PLANNING AND ZONING COMMISSION MEETING

CITY OF CREVE COEUR, MISSOURI

TUESDAY, JANUARY 16, 2018

APPLICATION TO PLANNING AND ZONING COMMISSION #16-031 FOR THE REZONING, CONDITIONAL USE PERMIT, AND SITE DEVELOPMENT PLAN AND BOUNDARY ADJUSTMENT APPROVAL OF A MOBIL ON THE RUN CONVENIENCE STORE WITH GAS PUMPS AND BRITEWORX CAR WASH FACILITY LOCATED AT 11109-11141 OLIVE BOULEVARD & 11100-11114 OAK LAKE COURT, CURRENTLY ZONED GC GENERAL COMMERCIAL AND C SINGLE FAMILY RESIDENTIAL

Figure 1: Close-up of the Applicant's Site Development Plan reviewed on December 4, 2017

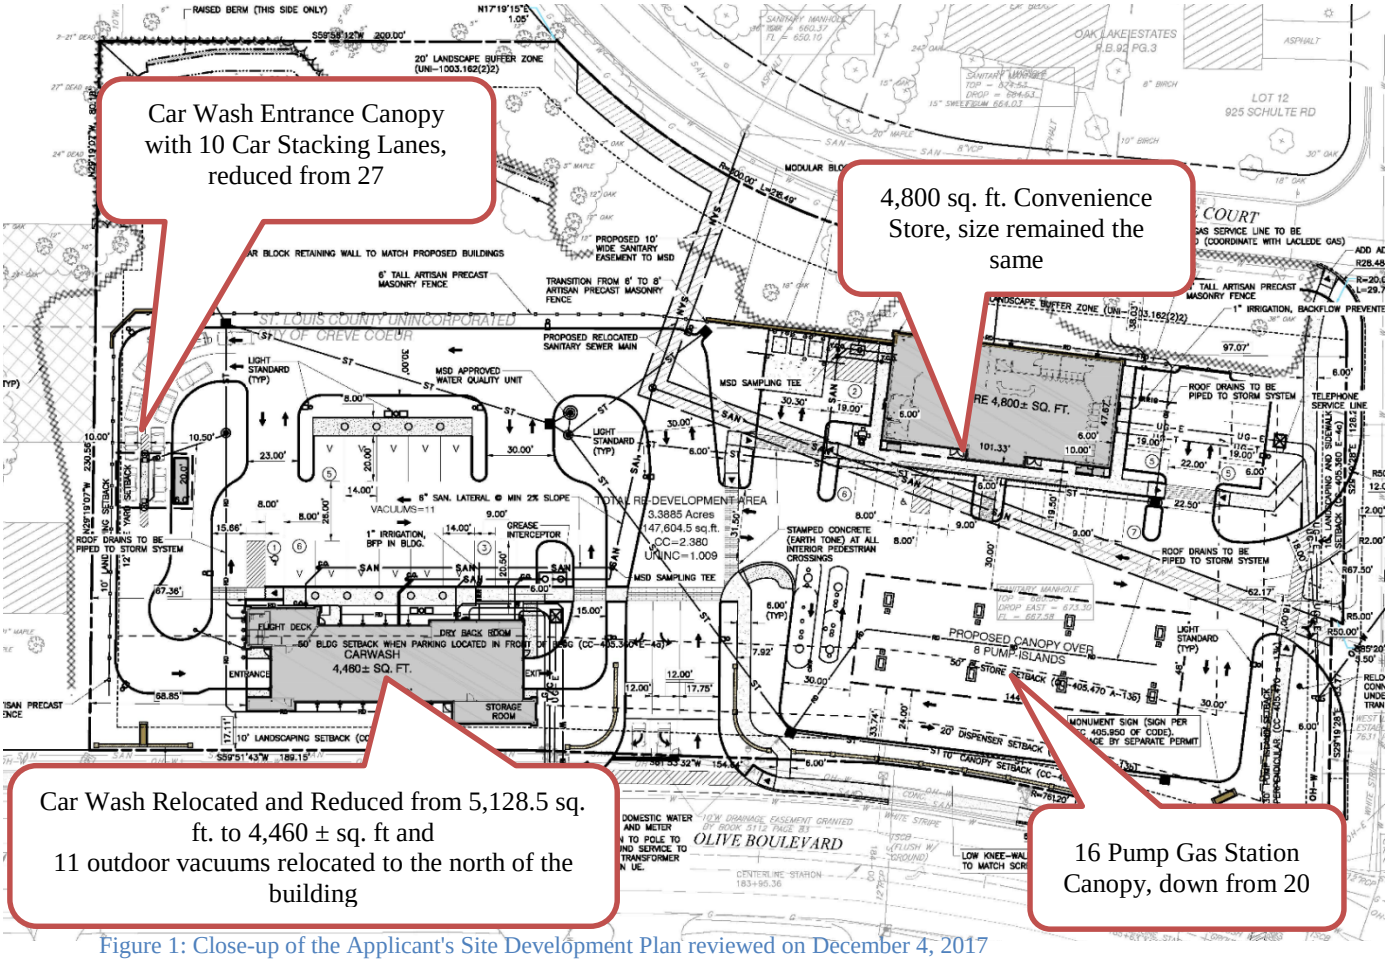
As requested by the Planning and Zoning Commission, the Applicants have submitted renderings to provide a perspective of the proposed development and have made minor changes to the architectural elevations as noted in the Narrative submitted on 1-9-2018 in the attached materials. All other aspects of the proposal remain the same.

Below are the specific changes that have been made, as shown in the revised drawings:
